Architect's Supplemental Instructions (ASI's)

Project: Ellis Glen
Issue Date: August 22, 2024 (drawing dated August 22, 2024)
ASI No.: ASI- 01

ARCHITECT'S SUPPLEMENTAL INSTRUCTION NO: ASI- 01
CONTRACT FOR: Ellis Glen
ORIGINAL DRAWINGS DATED: 18 March 2024

The following plan changes were requested by the owner and made to the permit documents. These changes shall be incorporated:

UNIT B3-A FLOOR PLANS

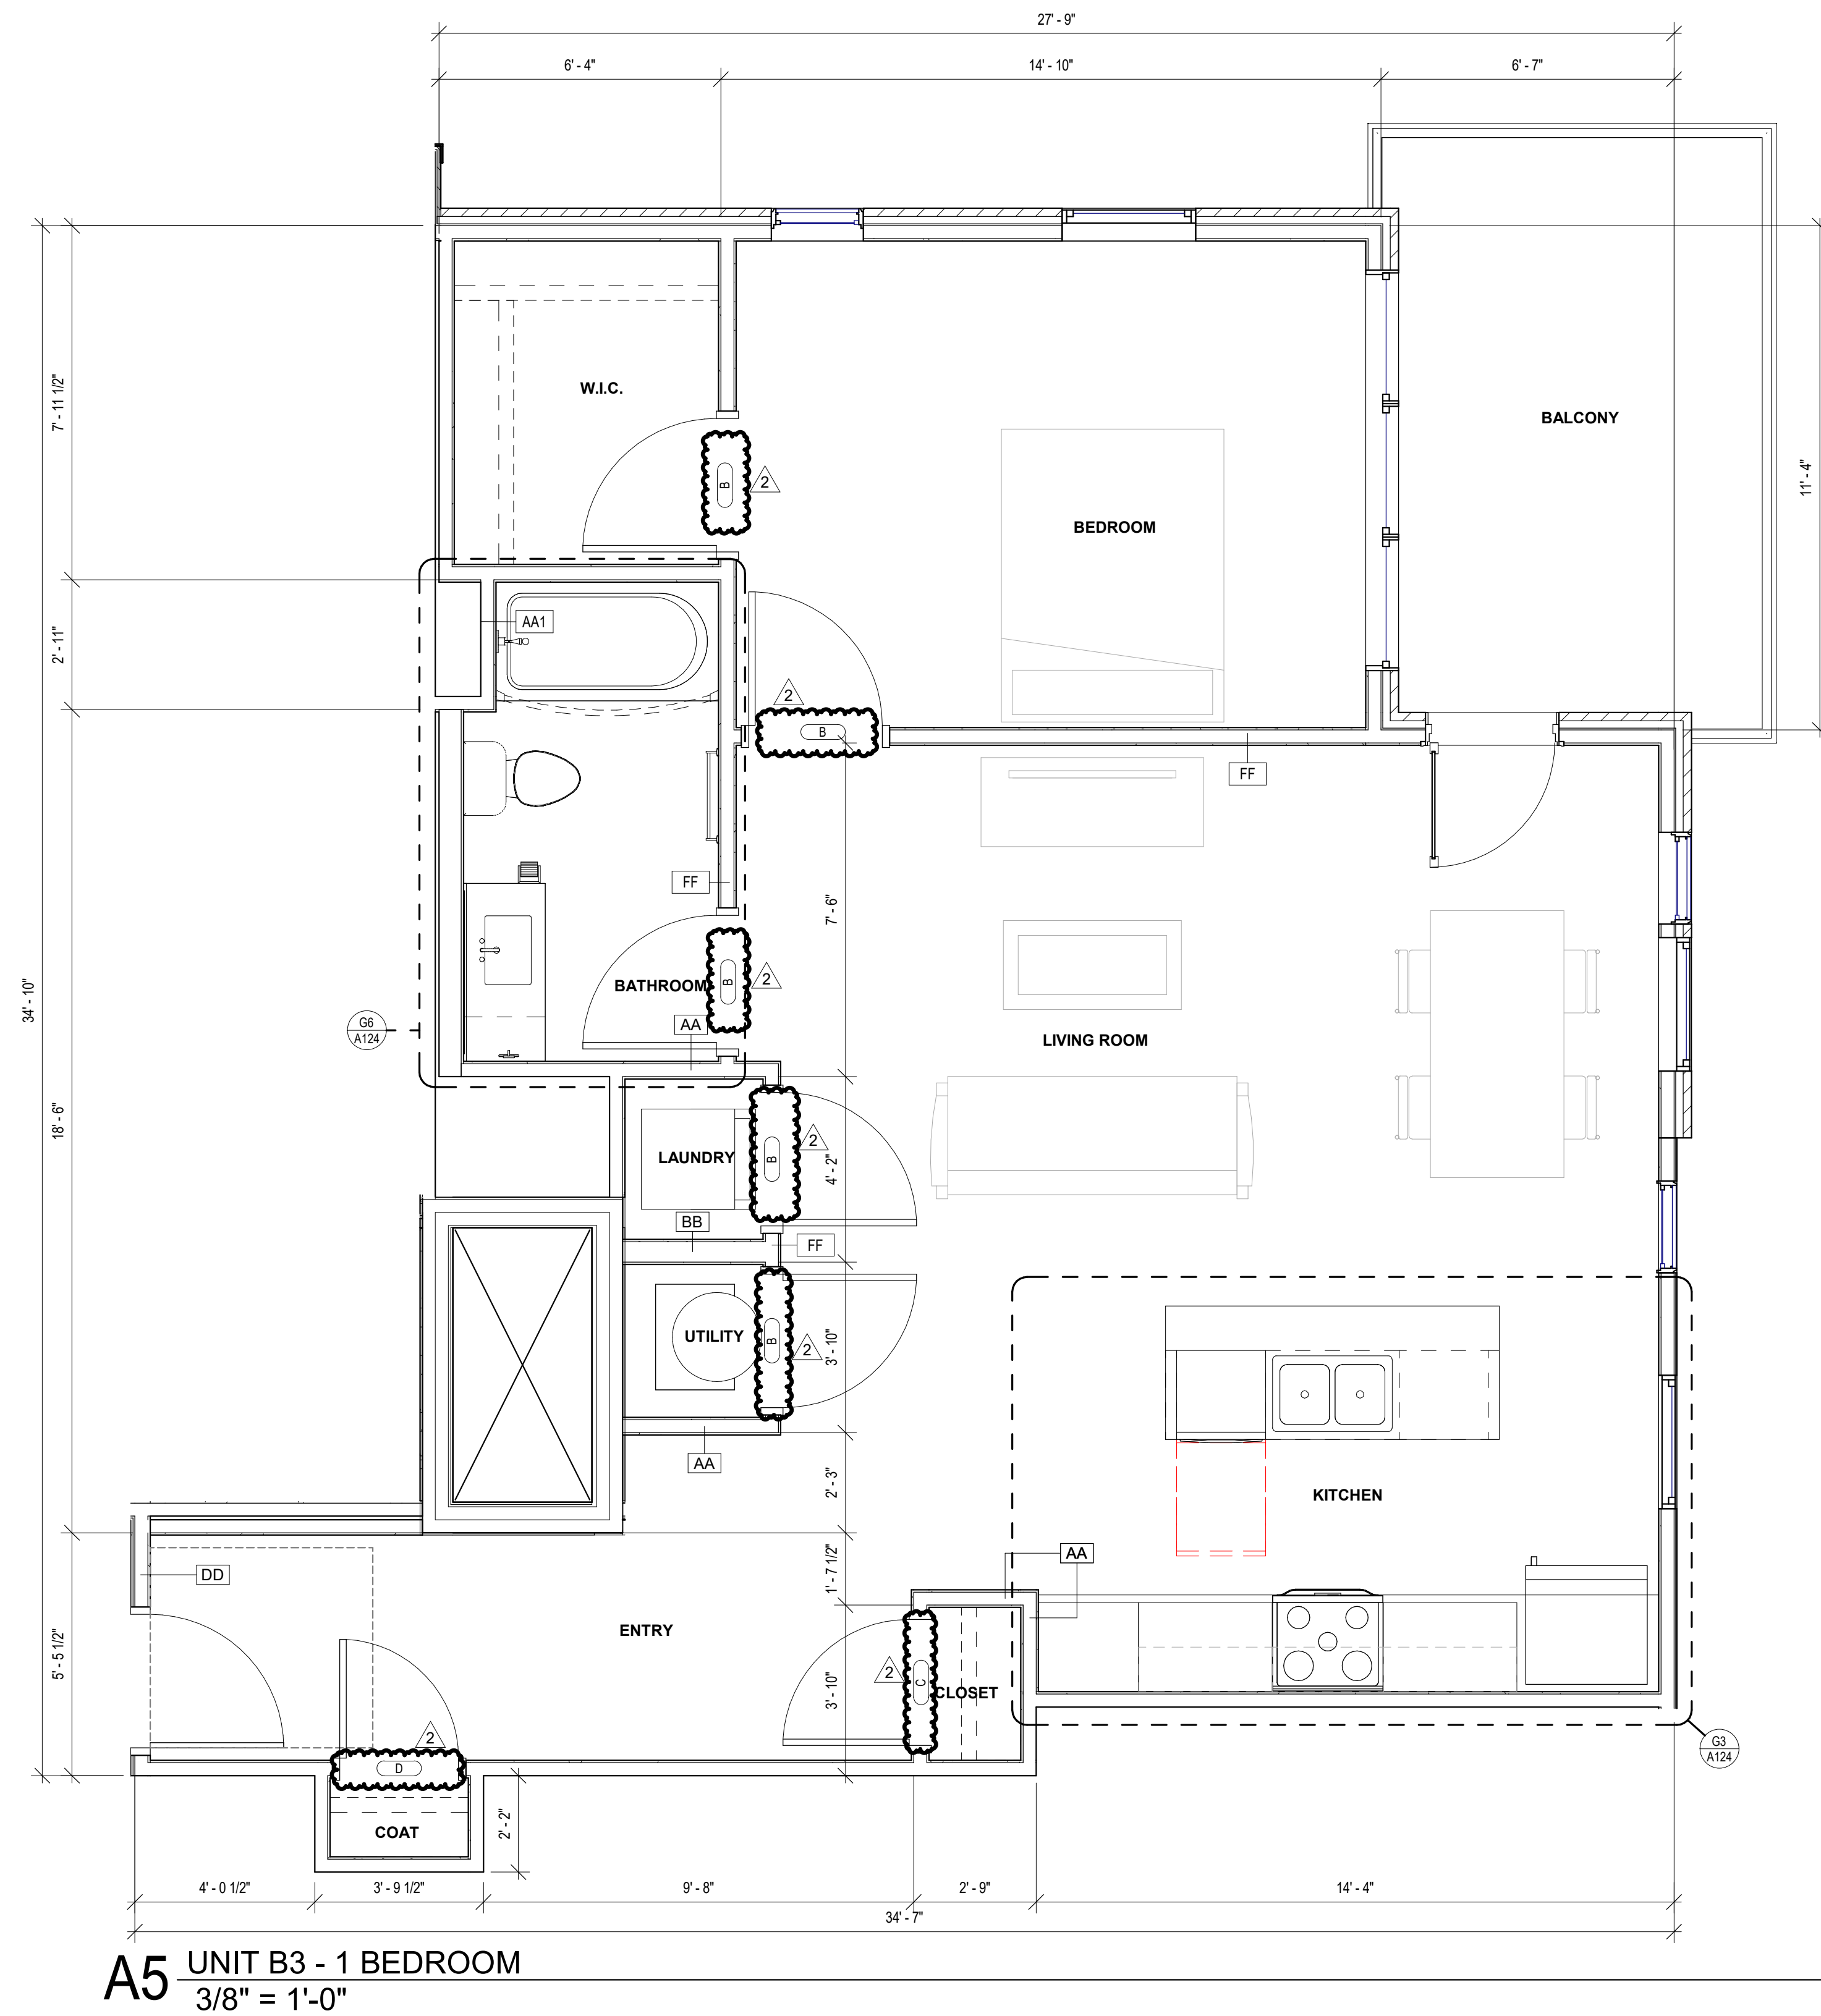
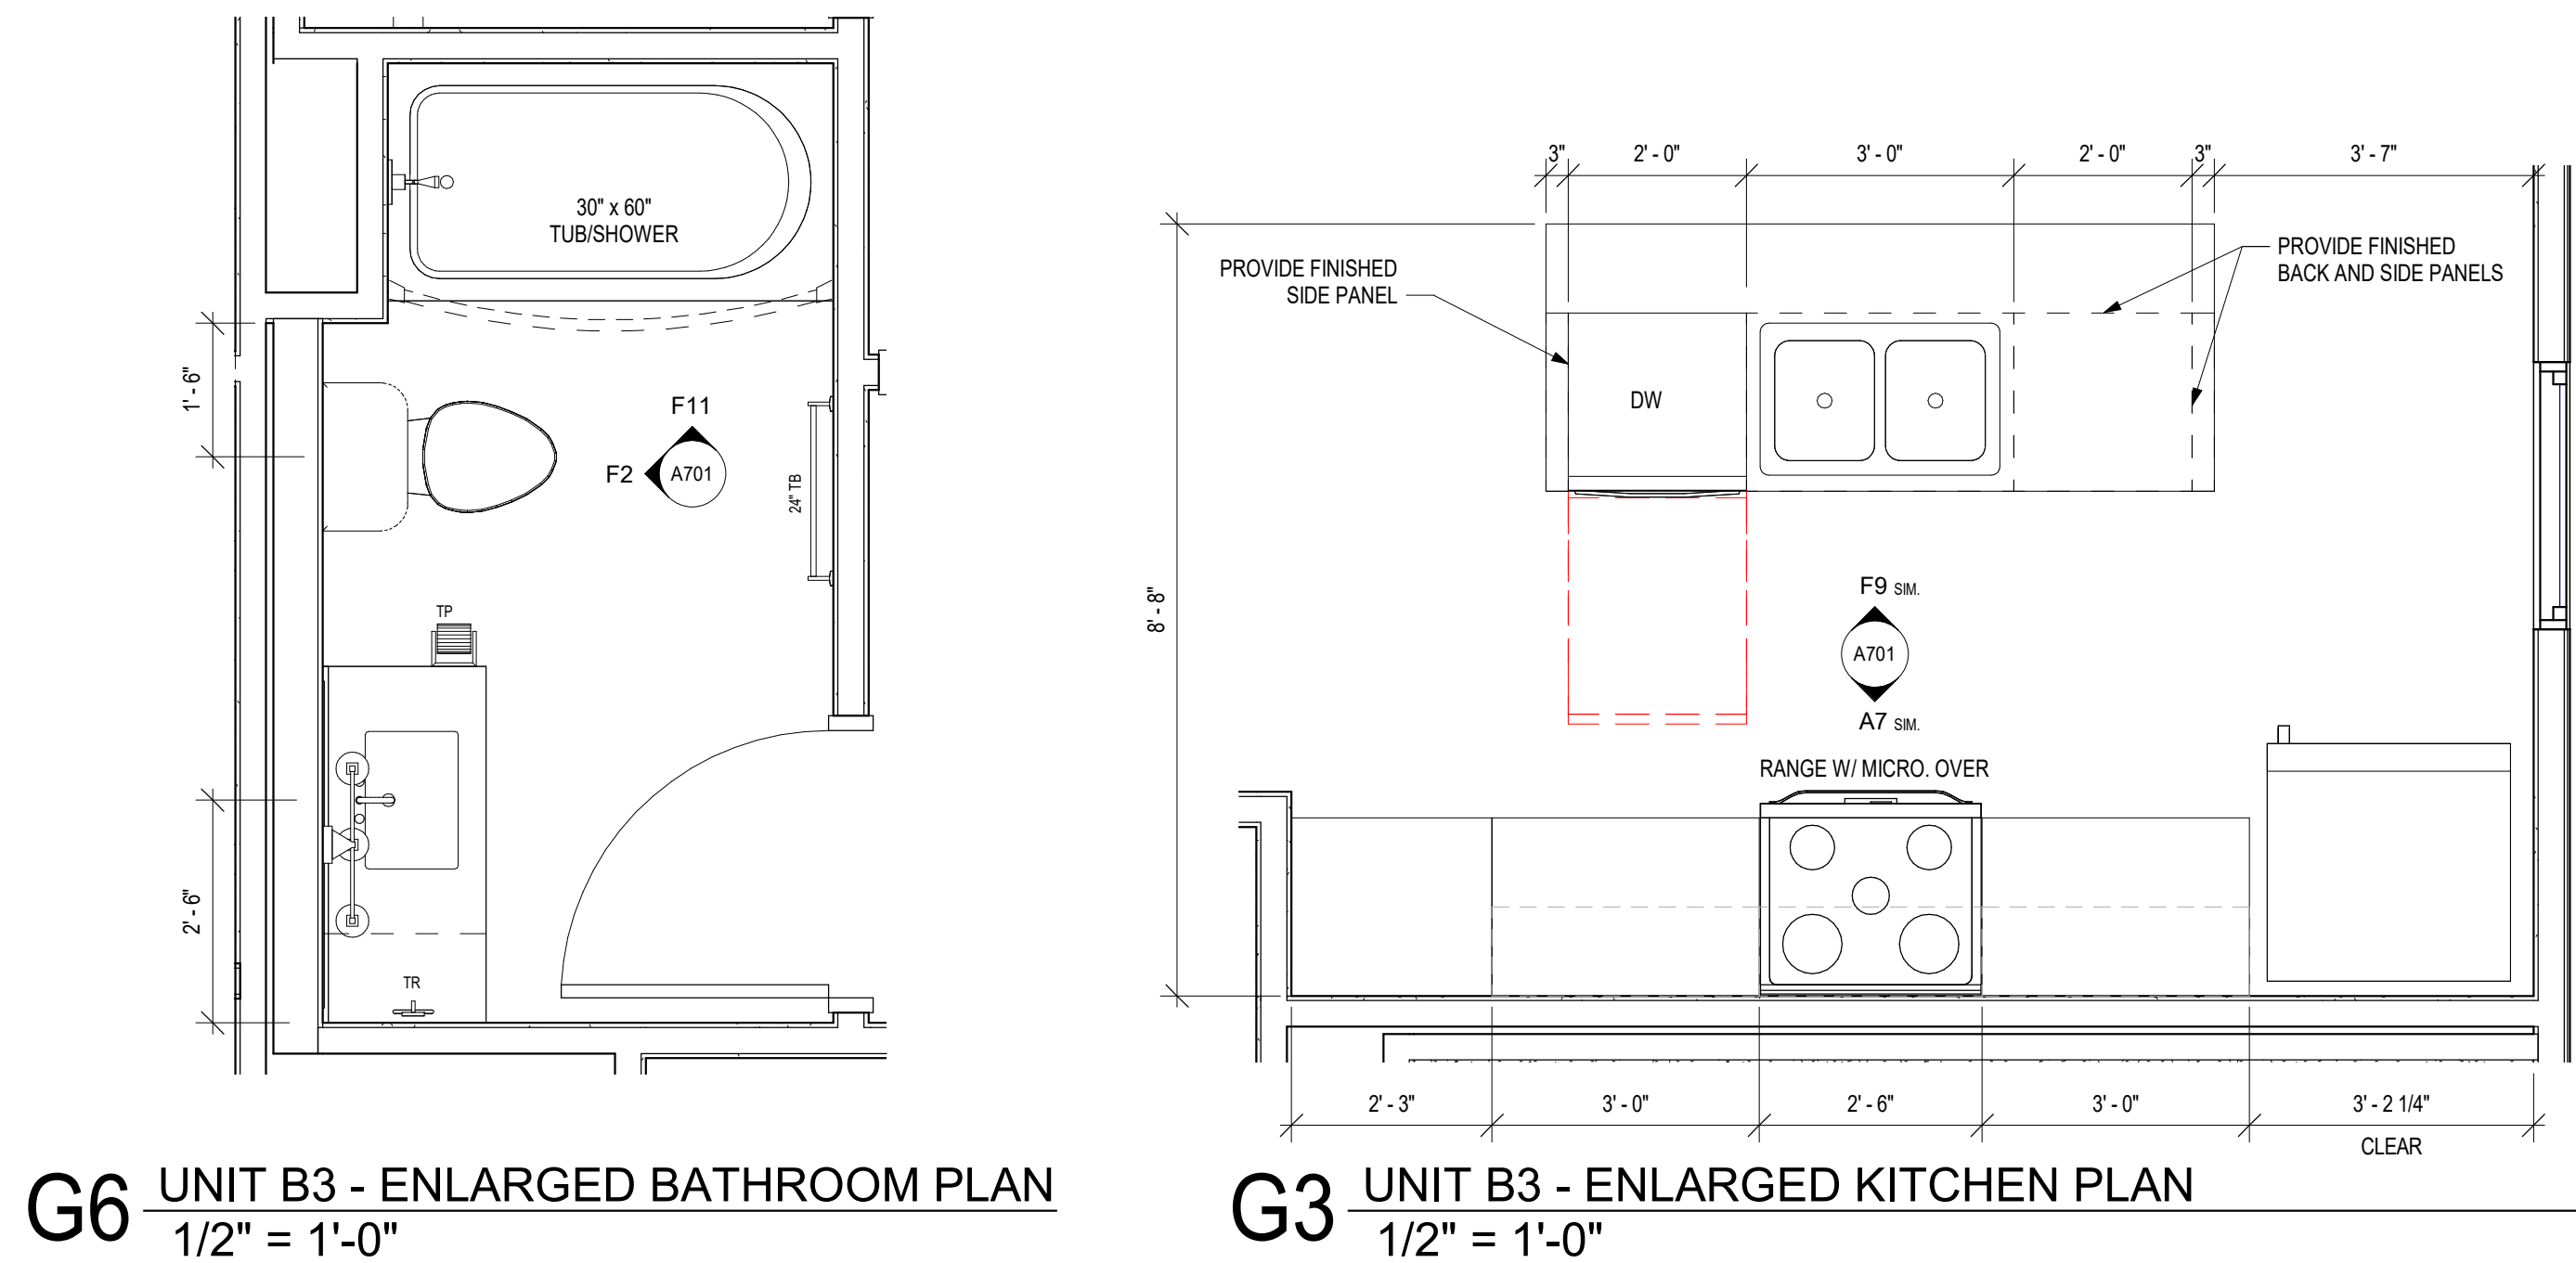
A125 – Unit B3-a Plan

1. Floor updated to accommodate a side-by-side washer and dryer in a larger closet. The mechanical closet was slid down to align with the entry wall. The door to the laundry closet was changed to be Type F (found in other units on the project).
